Subject: Issuance of Amendment No. 35 to Facility Operating
License No. NPF-21 - WPPSS Nuclear Project No. 2

AMENDMENT NO. 35 TO FACILITY OPERATING LICENSE NO. NPF-21
WPPSS NUCLEAR PROJECT NO. 2

SAFETY EVALUATION BY THE OFFICE OF NUCLEAR REACTOR REGULATION

SUPPORTING AMENDMENT NO. 35 TO FACILITY OPERATING LICENSE NO. NPF-21

FIGURE 3.4.6.1-1

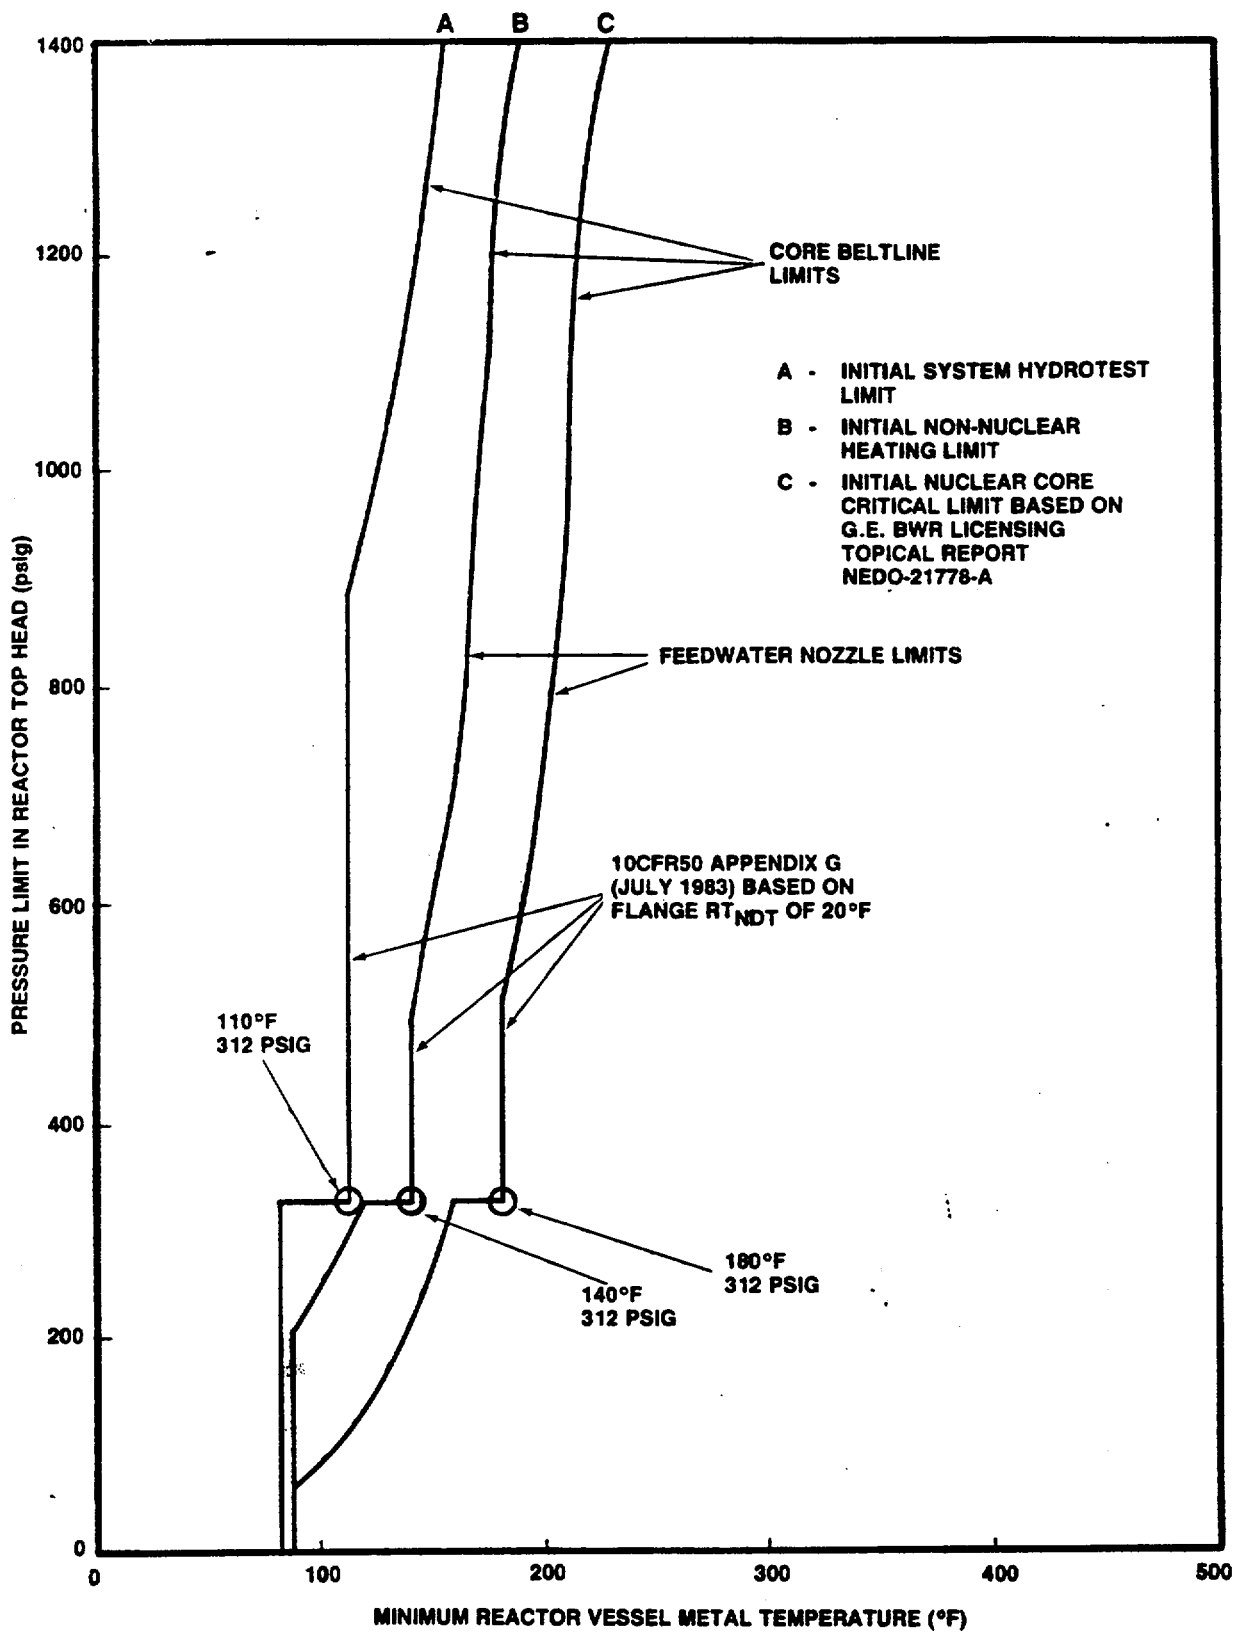
This amendment revises Sections 3.4.6.1 (Pressure/Temperature Limits) of the WNP-2 Technical Specifications by shifting the relationships in the pressure/temperature curves, Figures 3.4.6.1-1 and 3.4.6.1-2, 30°F higher at 20% of the preservice hydrostatic test pressure. This change is in compliance with the requirements of paragraph IV.A.2 of 10 CFR Part 50, Appendix G.

In a letter to the Commission dated January 31, 1986, the Washington Public Power Supply System requested an amendment to Section 3.4.6.1 of the WNP-2 Technical Specifications. The request was made to revise Figures 3.4.6.1-1 and 3.4.6.1-2 in order to comply with the requirements of paragraph IV.A.2 of Appendix G of 10 CFR Part 50.

The revised pressure/temperature curves have been shifted 30°F higher at 20% of the preservice hydrostatic test pressure for compliance with the requirements of paragraph IV.A.2 of Appendix G. Because the revised curves are more conservative, they will provide an additional margin of safety for reactor vessel testing and operation; and because the changes are required by the regulations, they are acceptable.
